**Agenda for the Special Meeting of
The Board of Commissioners**

**Fidalgo Pool and Fitness Center
Facility Audit
Anacortes, WA**

White Paper – Fidalgo Pool & Fitness Center Replacement

B. Perimeter Overflow System

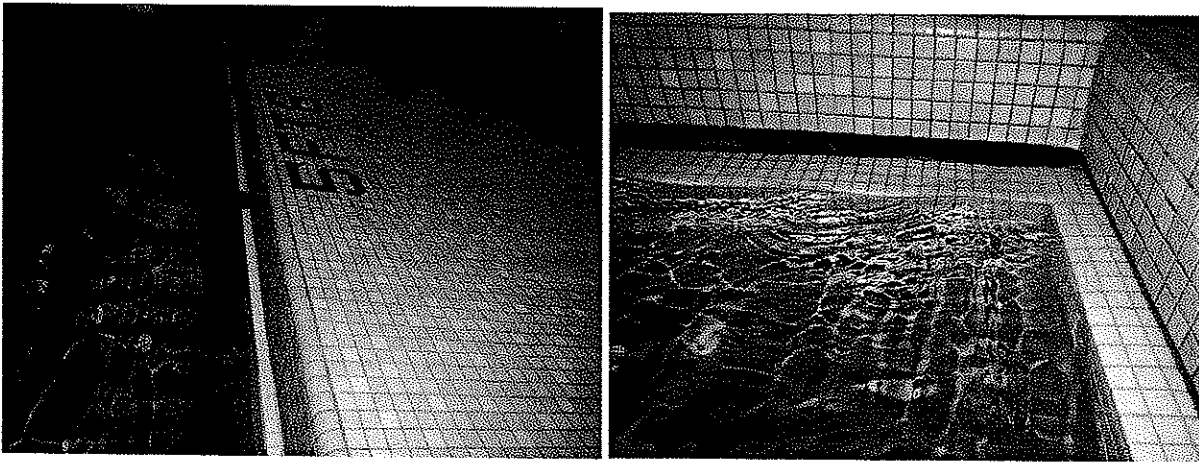
A fully-recessed gutter with an all-tile finish is provided for surface skimming around the pool perimeter. The gutter system is in fair condition and has noticeable staining of the tile, but very few tiles were observed to have delaminated. The pool gutters drain by gravity to the surge pit through a 10" pipe that can handle up to 672 GPM at 3 ½ ft/sec. This piping is rated to handle 83% of the overall flow for the pool.

The current Washington Administrative Code requires overflow gutters shall be capable of continuously removing no less than 100% of the recirculated water, which is not met with the current flow rate and gutter capacity. The ability for the gutters to be able to handle 100% of the pool's flow is generally recommended and an industry design standard.

C. Main Drains

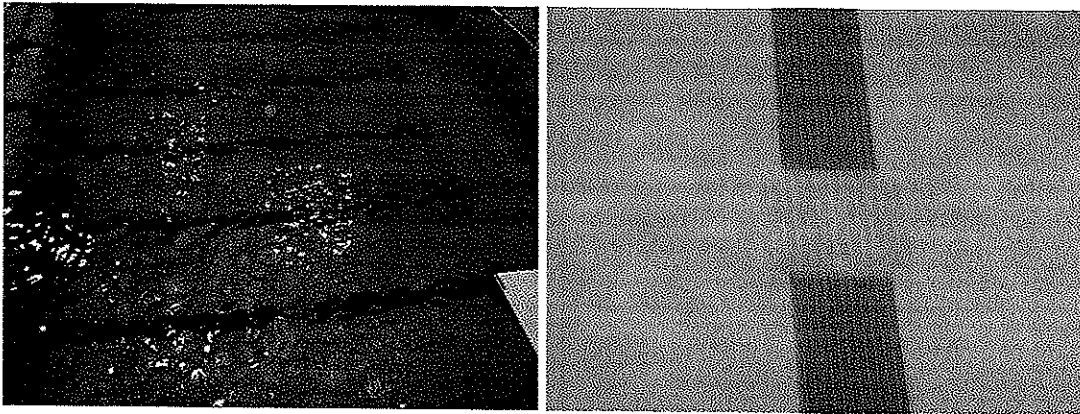
There are two (2) 24" x 24" square, fiberglass main drain covers located in the deep part of the competition pool. The main drains appear to have secured grate covers that are suction and hair entrapment certified as required by the Virginia Graeme Baker Pool and Spa Safety Act (VGB), ASME/ANSI A112.19.81.

All main drains with dimensions 18" x 23" or smaller are classified as "blockable" and must have a VGB stamped and certified "unblockable" grate cover with tamper proof screws. The federal regulations of VGB were passed by Congress in 2008 and are designed to reduce the potential for suction and hair entrapment in commercial swimming pools at all suction outlets (e.g. main drains, skimmer equalizer lines, etc.). The Consumer Product Safety Commission (CPSC) is tasked with federally enforcing all VGB regulations, but due to the vast number of commercial swimming pools in the United States, enforcement most commonly is the responsibility of the local governing agencies (e.g. public health departments, building departments, etc.).

Staff report that the main drain is gravity-fed. It is routed to a single 10in pipes that is rated 672 GPM at 3 ½ feet per second. The CH standard is for the main drain piping to be rated to handle 100% of the circulation, which is not met by the single 10" pipe at the observed flow rate of 803 GPM.

D. Inlets

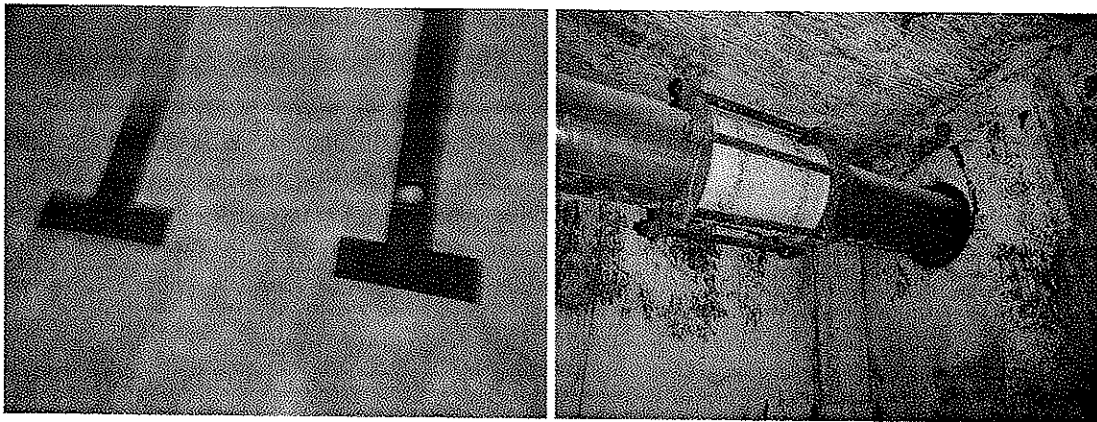
The pool is equipped with 12 floor inlets in the shallow end and 6 floor inlets in the deep end. The inlets are fed with a 8" supply line that is rated for up to 812 GPM at 8 feet per second and 975 GPM at 10 feet per second. The flow rate of 803 GPM falls within the rating for the current piping.

Of the two inlet systems (floor and wall), the floor inlets are usually recommended over wall inlet systems for larger pools. The reason is that a relatively equidistant location of the floor inlets provides a more uniform distribution of filtered water over the floor. This situation affects, in a positive way, the subsurface turbulence created by the swimmers overhead. The floor system also provides a "sweep and clean" movement of the water across the pool floor, picking up small dirt and debris.

The Washington Administrative Code requires inlets to be located on the bottom of swimming and wading pools over twenty-five hundred square feet and spa pools greater than ten thousand gallons. The current inlets meet this requirement.

E. Ingress and Egress

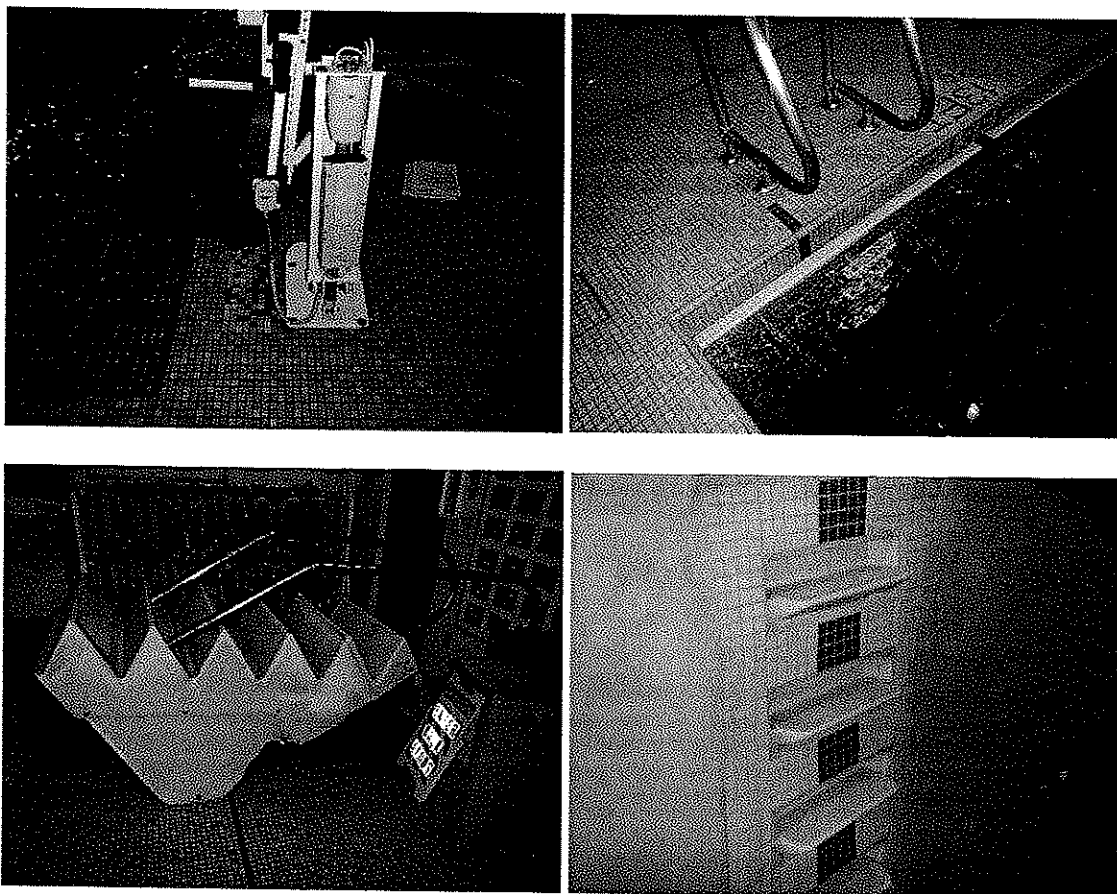
The pool has deck-anchored stainless steel grab rails with embedded steps located around the pool perimeter in the wall. A compliant Americans with Disabilities Act accessible means of entry is provided for the pool. The ADA Act requires that a swimming pool with a perimeter that is more than 300' have at least two accessible means of entry and requires accessible lifts to be capable of unassisted operation from both the deck and water levels. Controls and operating mechanisms shall be unobstructed when the lift is in use.

The pool also has two fiberglass stairs with stainless steel grab rails as an alternative means of entry and exit for the pool. The handrails on the stairs are 27" apart and do not comply with the ADA standard 1009.6.2 Handrails, which stipulates handrails must be within 20" and 24".

"1009.6.2 Handrails. The width between handrails shall be 20" (510 mm) minimum and 24" (610 mm) maximum. Handrail extensions required by 505.10.3 shall not be required on pool stairs."

C. Diving Boards

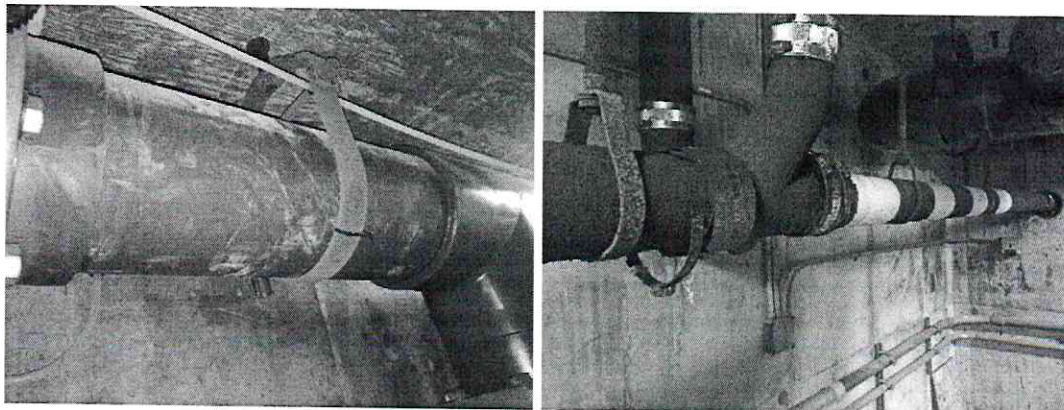
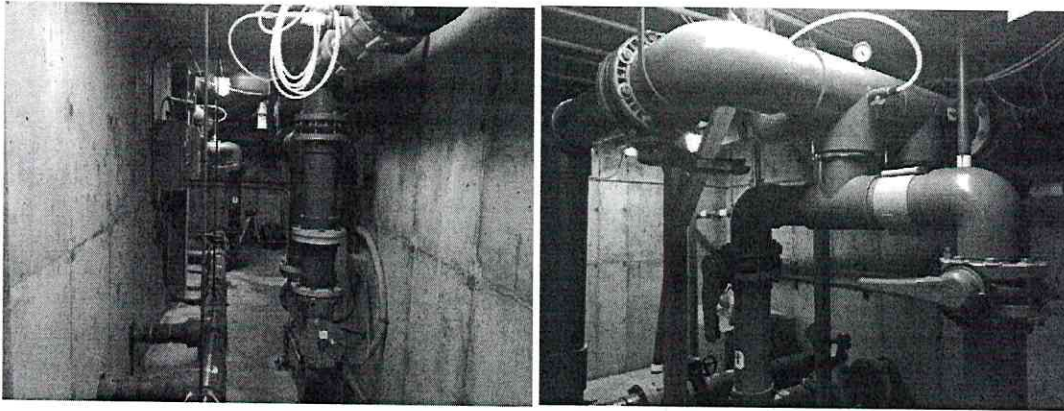
A single 1-meter diving board is provided. The board is mounted on a concrete pedestal and is in good condition. When comparing the existing diving well dimensions to the dimensional requirements of NFHS, FINA and the NCAA, the following items were observed: (diagrams illustrating these items are found below)

The pool meets the current 1-meter depth/slope requirement for NCAA, FINA and High School.

C. Flow Meter

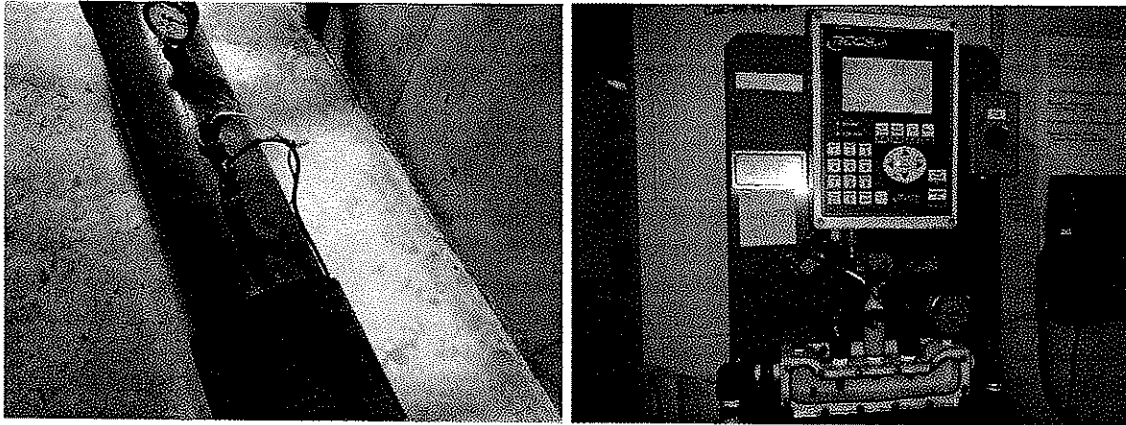
There are two flow meters installed on the pool, one is an acrylic flow meter and is installed on the pressure piping back to the pool, downstream from the filter, which is the preferred place for mounting. The other is tied directly into the BecSys chemical controller. Flow sensors should be installed with at least ten pipe diameters downstream and five pipe diameters upstream on a straight run of piping.

The flow meter was giving a reading of 803 GPM which places the turnover at 5.8 hours. According to the Washington State Code, "Owners of swimming pools shall design and maintain water treatment recirculation rates to completely turn over the entire pool water volume of pool in six hours or less." The Fidalgo Pool meets this requirement.

D. Filtration System / Surge Tank

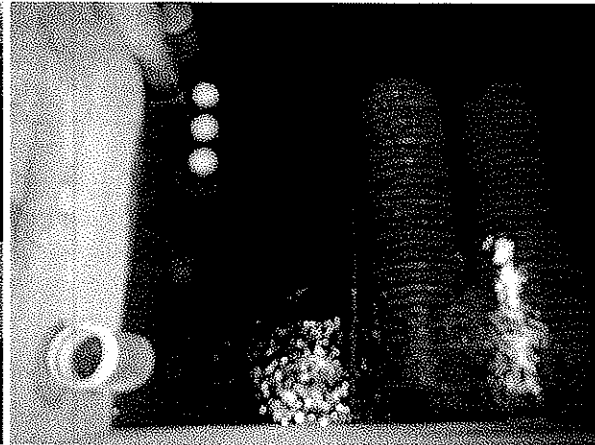
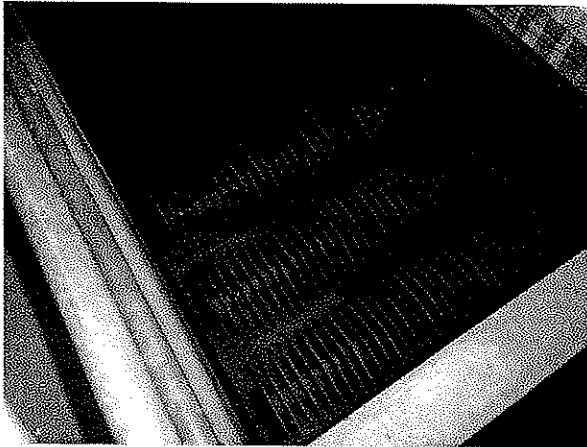
The pool uses open-air vacuum Diatomaceous earth (DE) filters for its filtration. This system was installed during the initial construction. While these filters have served the facility well and provided ample water quality over the years, it is an antiquated system and should be replaced during a facility renovation with either high-rate sand filtration or regenerative media filtration.

The size and capacity of these filters could not be verified by nameplate on site during the audit, but staff notes have estimated each disc at 26 inches of diameter, equaling 121 SF of total surface area. The standard flow rate for this type of filtration system is to stay within 1 to 3 GPM/SF of surface area. With a flow rate of 803 GPM, the filtration rate is calculated at 6.6 GPM/SF which exceeds the industry standard for this type of filter by more than double.

Washington State Code requires the capacity in gallons of the surge tank to equal the square footage of the pool. This would require the surge tank to hold 5,040 gallons.

E. UV System

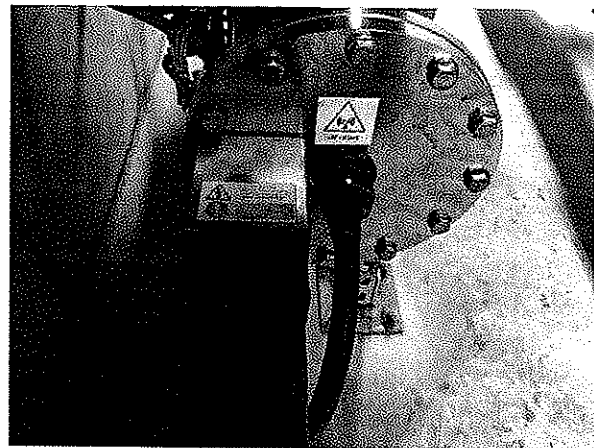
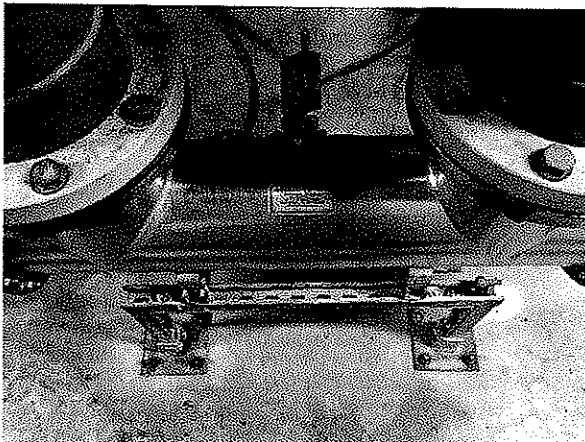
The pool mechanical system contains a Hanovia Ultraviolet Light Water Treatment System (UV). UV becomes beneficial in water treatment applications due to its ability to eliminate combined chlorine (also known as "chloramines") and kill chlorine resistant pathogens. While UV does break down free chlorine, the good form of chlorine used for pool disinfection, it is still highly recommended due to its ability to eliminate chloramines. Lower levels of chloramines lessens the corrosive off-gassing which attributes to the corrosion of deck equipment, HVAC, and internal structures of some facilities. Additionally, chloramines are typically responsible for the odor and irritation experienced by athletes, coaches and staff.

Eliminating chloramines creates a healthier and more enjoyable environment for facility users and staff. A UV system should be included in any future mechanical system renovations, or the construction of a new aquatic facility. Not only will UV systems kill pathogens and chloramines, but they will also eventually provide cost savings. It is common for a UV units to help lengthen and enhance the life expectancy of building materials, dehumidification units, etc. due to the elimination of combined chlorine before it is released into the air and causes corrosion of these materials.

F. Chemical Treatment System

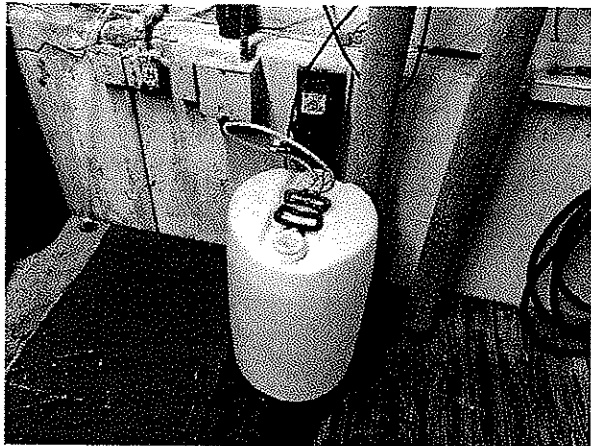
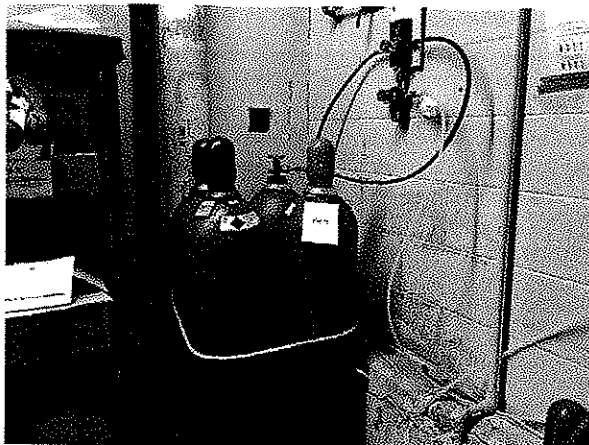
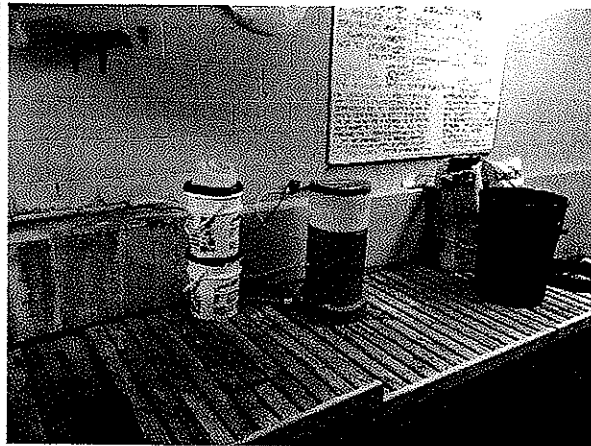
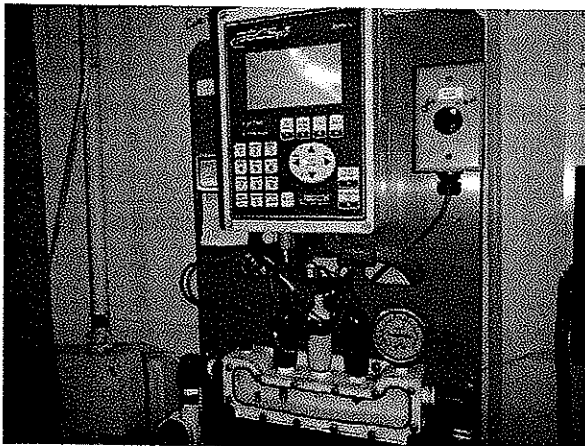
Currently the pool chemicals are located in the same area as the pool mechanical room. The pool is sanitized with Calcium hypochlorite (tablet chlorine) through a Pulsar 3 system and both CO2 and muriatic acid are used as the pH buffer. The 50 lb. buckets of calcium hypochlorite are stored inside the pool mechanical room on a platform above the surge tank. The muriatic acid and CO2 are stored in the same area, next to the chemical controller.

According to the Washington State Code, "Owners shall provide a separate chemical storage area or room that conforms to manufacturer's requirements for each chemical used in the pool area." A separate dedicated and ventilated chemical storage room for both the sanitizer and pH buffer is recommended and is the current industry standard. The existing chemical storage area does not meet the current requirement or standard. Dedicated chemical storage spaces should be included in any future plans, whether for a renovation or a new facility.

The pool is controlled by a BecSys 5 chemical controller. The chemical controller automatically adds chlorine and the pH buffer, maintaining the proper chemical balance throughout each day. The controller is in good working condition and is appropriate for this type of usage.

G. General Observations

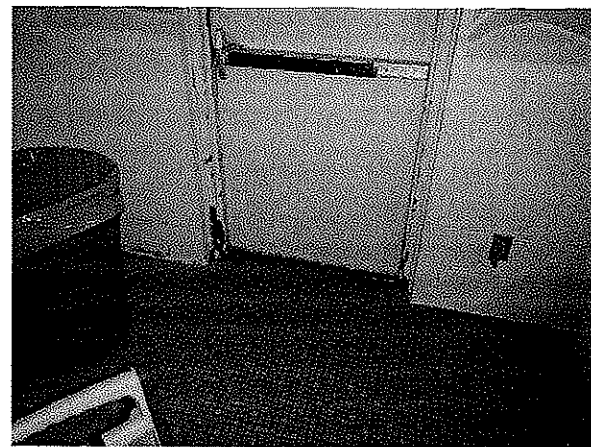
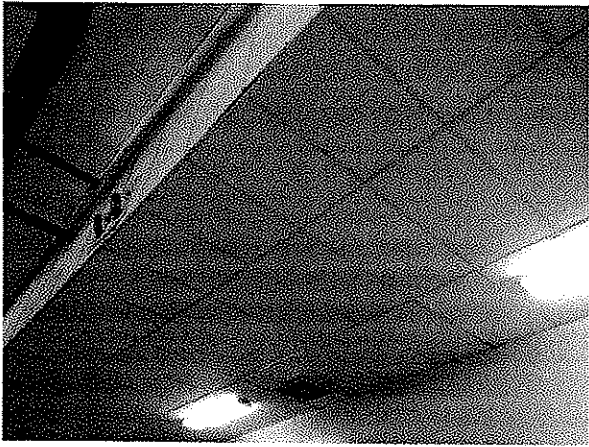
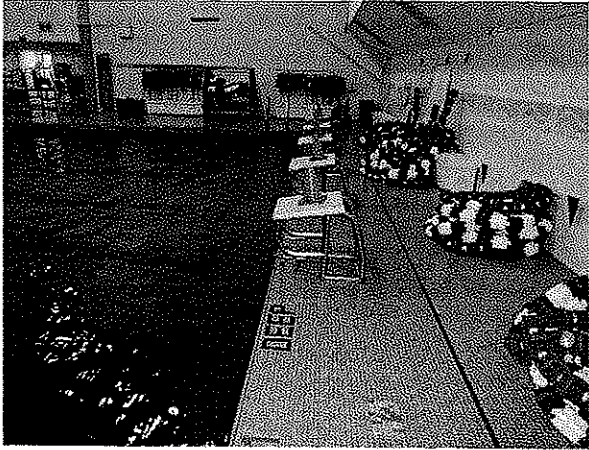
- There is not enough storage space at the Fidalgo Pool and Fitness Center. Currently the pool deck is used for storage for items such as the Daktronics timing equipment, lane ropes for the 25 meter course length, and swim lesson equipment (such as kickboards, floats and underwater benches).

- The deck space behind the starting blocks on the 25 meter course length is insufficient. Swim team staff report that during swim meets, there is not adequate room for timers, swimmers and coaches in this area, specifically during relay swims.

- The first two rows in the upstairs spectator seating for the swimming pool are not able to see the first two lanes during swim meets.
- Staff report that 60% of the ceiling material in the Fidalgo Pool has been renewed within the last 5 years with the entire south and east walls being new. Ceiling panels in a natatorium are usually made of galvanized steel with a coating of high-build epoxy coating. Other materials can be precast concrete, wood or aluminum. As with other materials in a natatorium, acoustical wall and ceiling must be corrosion resistant and interface with a vapor barrier, if necessary.

- User groups reported the air quality in the second-level spectator seating area is poor. Spectator areas should have higher air velocities of cool air (40 ft/min to 50 ft/min). Ceiling fans have also been used to improve spectator comfort. High velocity warm air in the face of spectators can be uncomfortable; therefore, cool air should be introduced over any raised spectator gallery for a major venue facility.

- Significant corrosion exists around the door frame on the east wall of the natatorium.
